Please find attached my second-round review of Mutter and Holschuh (manuscript number: egusphere-2024-2450) with manuscript title "Advancing interpretation of incoherent scattering in ice penetrating radar data used for ice core site selection". In general, I would recommend this paper to be published in The Cryosphere with minor revision, and I very much look forward to seeing the updated version soon. Please find below a series of additional comments. With best wishes, Julien Bodart

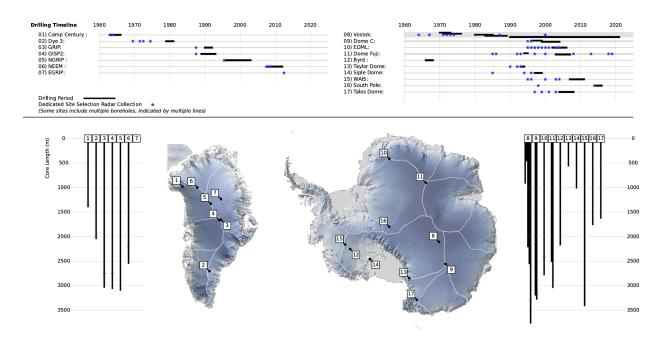
• Figure 1: Could I suggest an alternative to the "core length" diagram on the right-hand side of Figure 1? I was suggesting in my first review to add the age of the ice cores in a figure in the main text as I think it would help the reader who might not be familiar with the age depth at each core. The authors mentioned that this information was now in the supplementary materials, which is great. However, I believe that perhaps a good compromise (or opportunity) would be to order the cores in the diagram of Figure 1 by oldest to youngest (or reverse), so 1 in this scenario would be Dome C (currently 9), etc. This is motivated by the fact that there is no current logic behind the ordering of the cores in Figure 1, so ordering them by age would be an easy change that could address my comment (and the editor's).

We understand your desire to add age information to this figure, as it is an interesting dimension one can use to compare cores. We believe the current alphabetical listing makes ice cores more easily findable for the reader, and that additional information in the figure, while interesting, makes it less effective for its primary function – access to the ice thickness and location of each core site (relevant for deep deformation). But, we have constructed the figure as requested and include it in the supplementary figures (Fig. S5) for the manuscript.

Our earliest draft of the figure included more information about each core. Most notably, it included the timeline for site selection and exploration (as that is what motivated this work originally). In that version (provided below) we found that cross-referencing the figure and the text became more and more complicated, and as the figure got more information dense, the information we cared most about got lost in the noise. In redrafting the figures during the most recent round of review, we considered several options to include the age based on your recommendation, including re-ordering the cores, color-coding their labels based on maximum age, and more. We ultimately concluded that these modifications made it harder for the reader to quickly determine where cores were, the piece of information we care most about here.
